NOTICE OF DECISION

**CONDITIONAL USE / CLASS 3 DESIGN REVIEW / CLASS 3 SITE PLAN
REVIEW / CLASS 2 DRIVEWAY APPROACH PERMIT / CLASS 2 ADJUSTMENT
CASE NO. CU-DR-SPR-DAP16-06**

APPLICATION SUMMARY: A consolidated application for a Conditional Use Permit, Design Review, Site Plan Review, Driveway Approach Permit, and Class 2 Adjustment to allow for the development of a proposed 84-unit multiple family development on property located at 3271 Lancaster Drive NE.

HAROLD DRIVE APARTMENTS

SITE PLAN

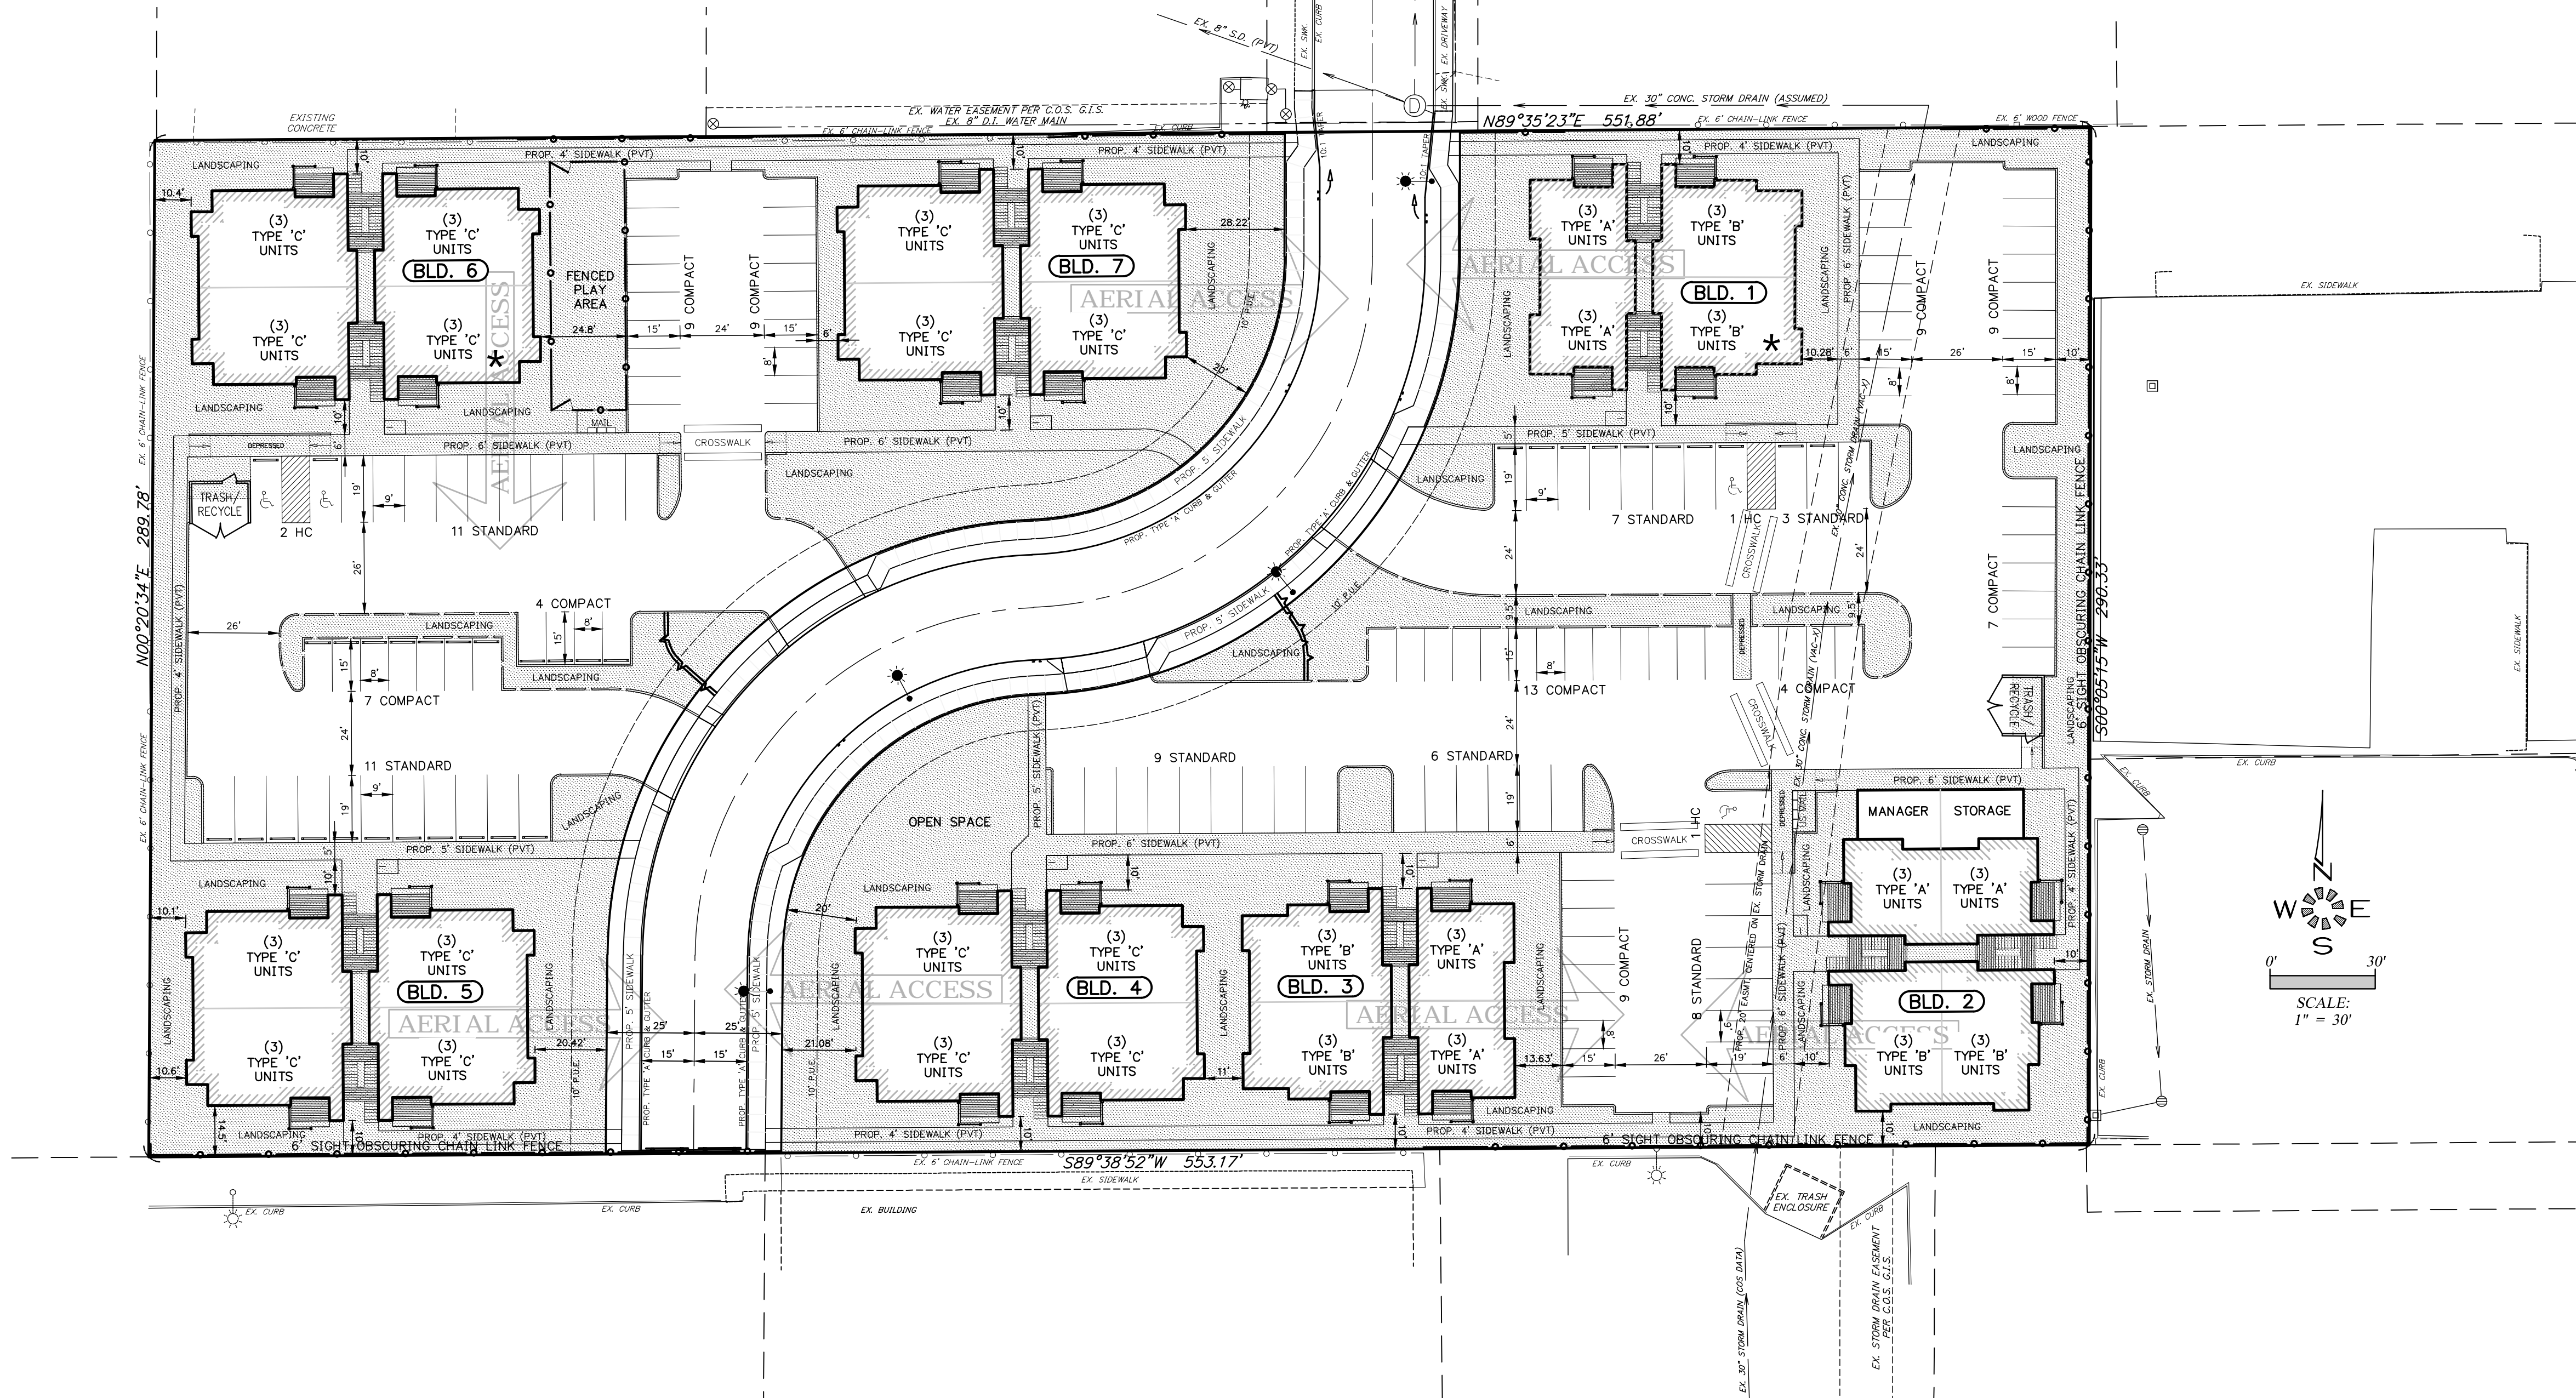
- a) Remove the first six parking stalls to the north of Building No. 4 that are located off the southern driveway approach on the eastern side of Harold Drive; or.
- b) Reconfigure the first six stalls to meet required setbacks. Compact stalls may be utilized to meet this requirement.

- Condition 1:** The site plan shall be revised to remove the first six parking stalls to the north of Building No. 4 that are located off the southern driveway approach on the eastern side of Harold Drive. Where the parking spaces are removed, they shall be replaced with landscaping.

**SCHEMATIC
LANDSCAPE PLAN**

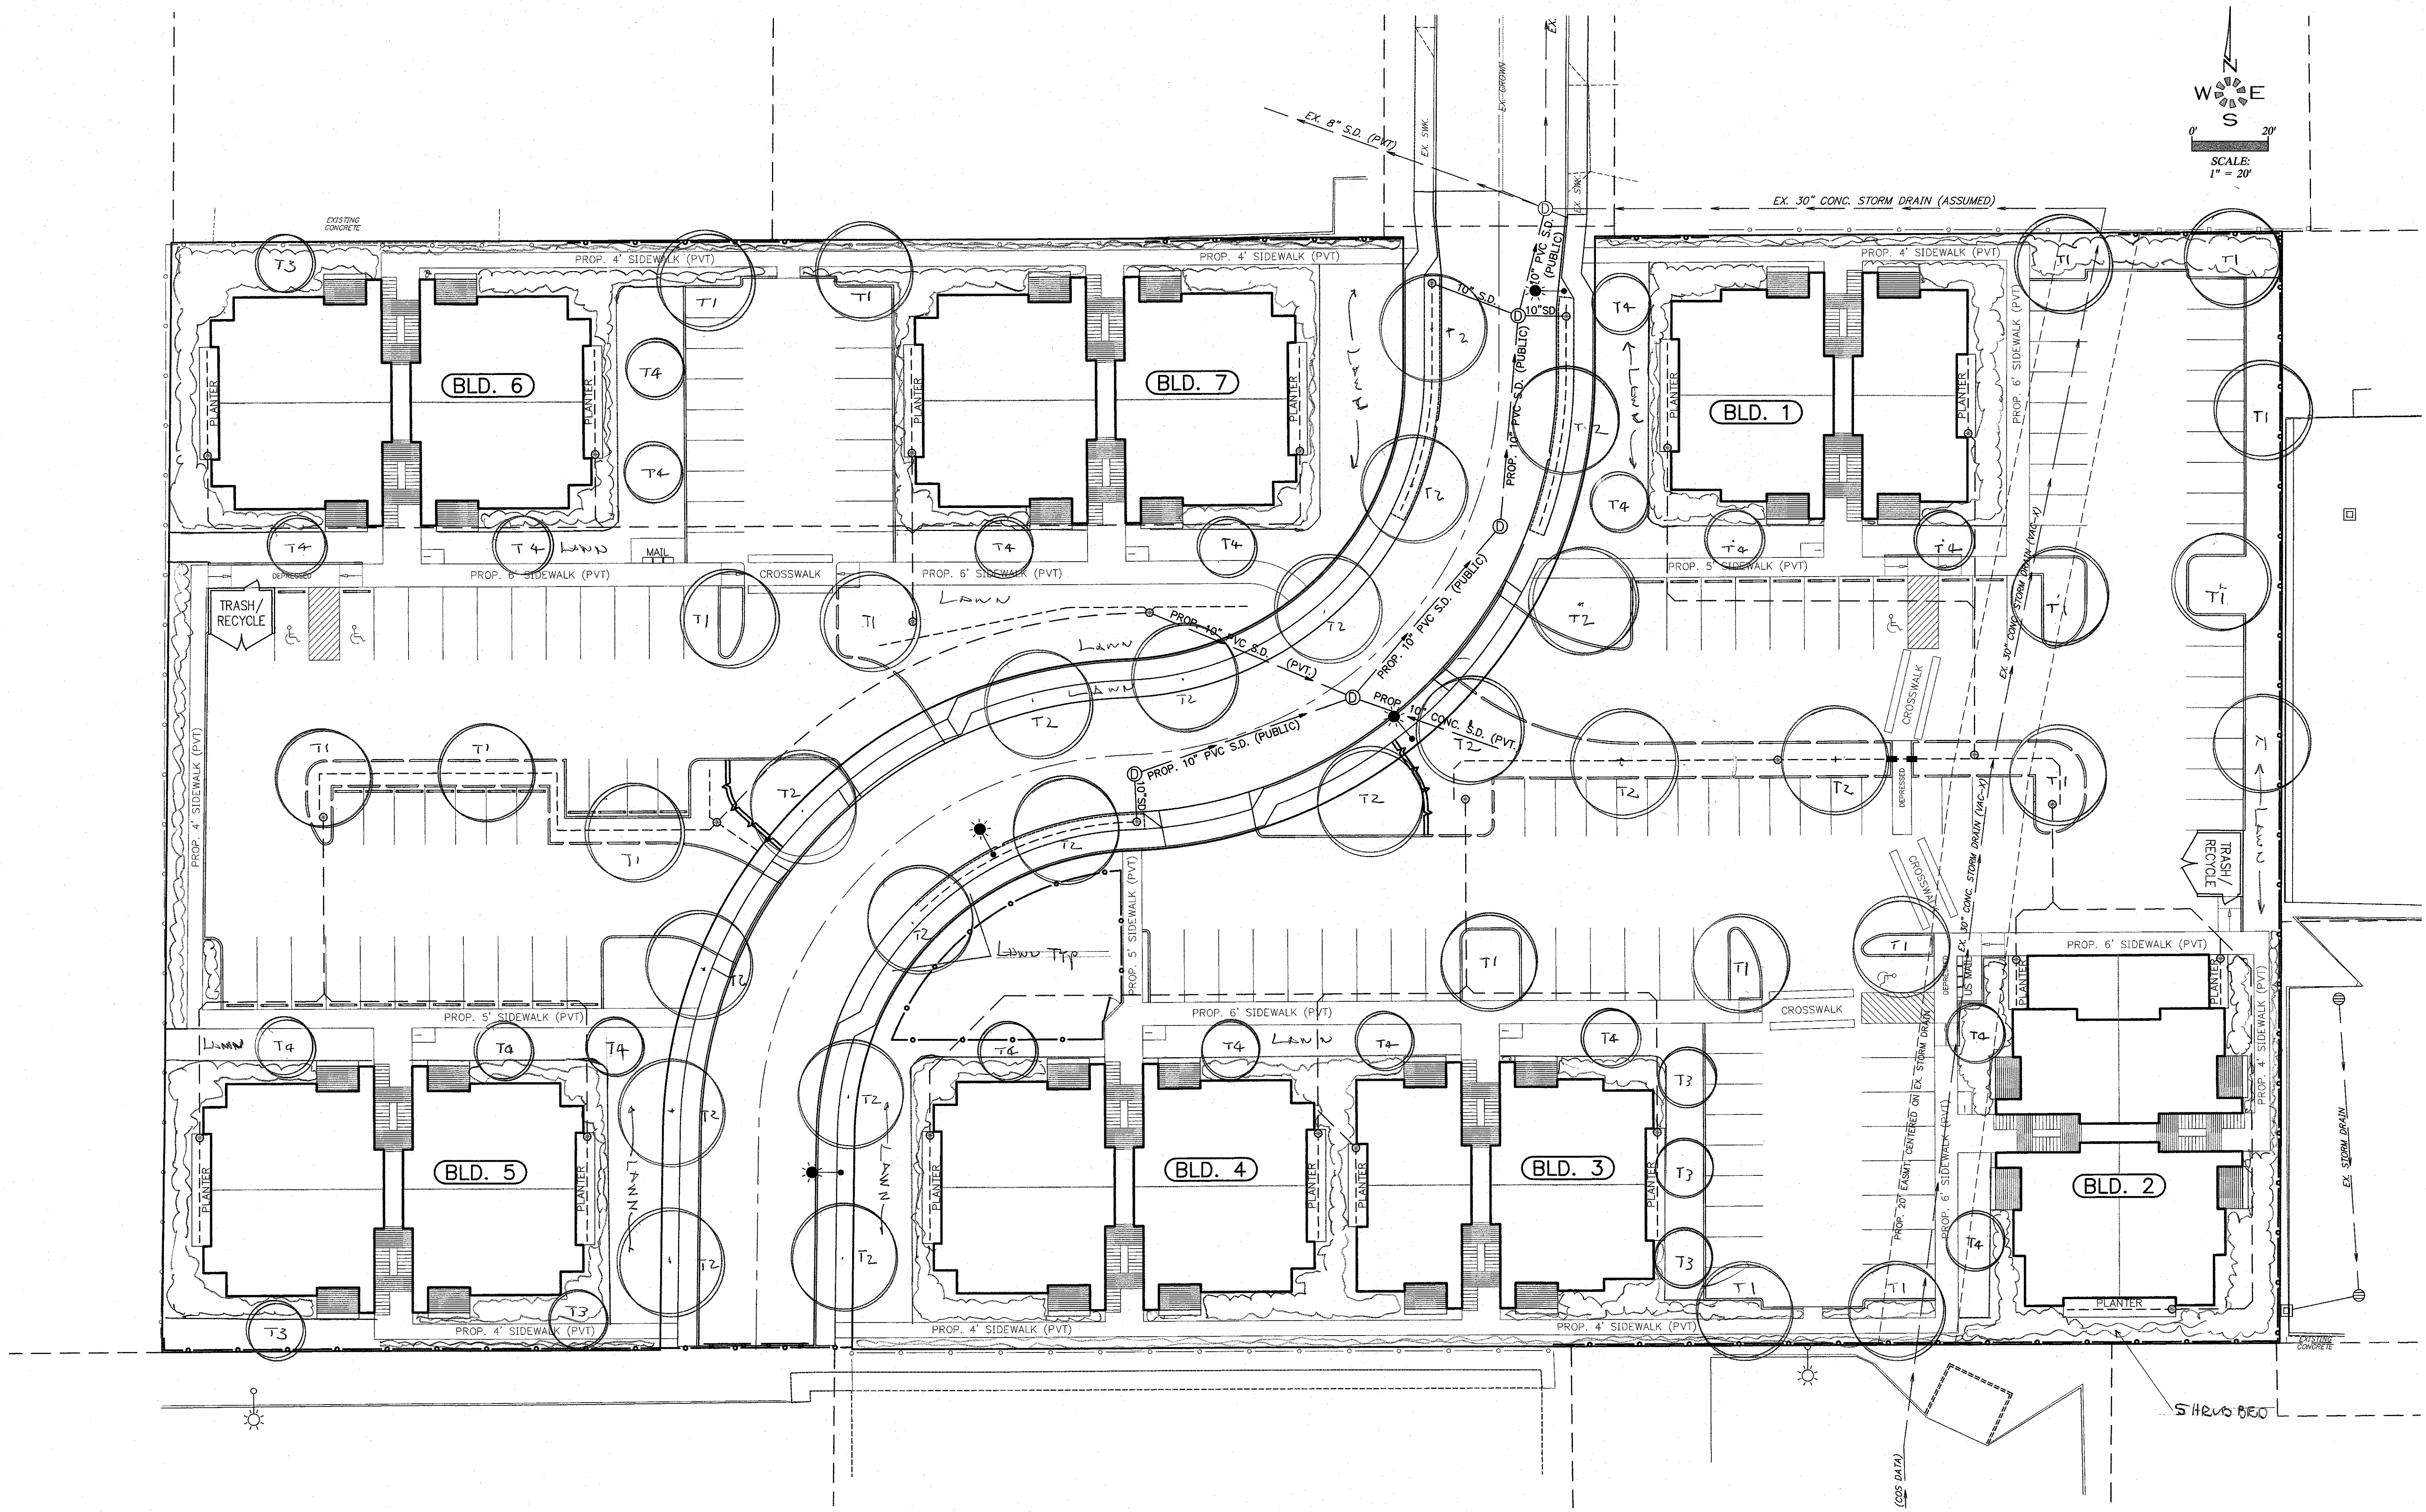
The landscape plan provided by the applicant shows specific numbers of trees and their species, as well as the proposed species of shrubs and ground covers to be included within the development, but does not, however, identify the specific numbers of plant units to be distributed around the proposed buildings. Because specific numbers and locations of plant units are not shown on the proposed landscape plan, the following condition of approval, based on the corresponding design standards, is recommended in order to ensure that the landscaping provided for the development will conform to this design guideline:

Because the landscape plan provided for the proposed development does not identify specific numbers and locations of plant units to be include within the landscape beds around the perimeters of the proposed buildings, the following condition of approval shall be required, based on the corresponding design standard, to ensure that sufficient horizontal landscape elements will be provided within the development along the exterior walls of the buildings to soften their visual impact and create residential character as required by this design guideline:

In review of the proposed landscape plan for the required numbers of trees to be planted around the perimeters of the proposed buildings, four of the proposed buildings, Buildings 1, 3, 5, and 6, conform to the minimum number of trees that would otherwise be required to be planted around their perimeters under the corresponding design standard. Buildings 2, 4, and 7, however, do not conform to the corresponding design standard.

Condition 5: Additional trees shall be planted around the perimeters of Buildings 2, 4, and 7 as follows:

- d) Building No. 2: One additional tree shall be planted adjacent to the southeast corner of the building.
- e) Building No. 4: One additional tree shall be planted adjacent to the southeast corner of the building and one additional tree shall be planted adjacent to the southwest corner of the building.
- f) Building No. 7: One additional tree shall be planted adjacent to the northeast corner of the building and one additional tree shall be planted adjacent to the southwest corner of the building.
